Interactive comment on “Reliability of water distribution networks due to pumps failure: comparison of VSP and SSP application” by N. Mehzad et al.

Responses of the authors to the reviewers' comments on the paper entitled “Reliability of water distribution networks due to pumps failure: comparison of VSP and SSP application” By N. Mehzad, M. Tabesh, S. S. Hashemi, and B. Atae Kia

Fig. 1. The comparison of reliability of two type of pumps (VSP, SSP), with weighted average of four scenarios using three nodal pressure equations.

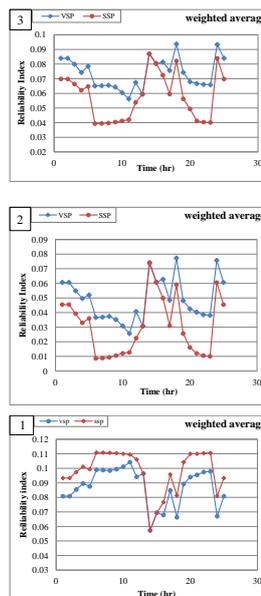
Appendix: figures in page 372 should be replaced by these figures.
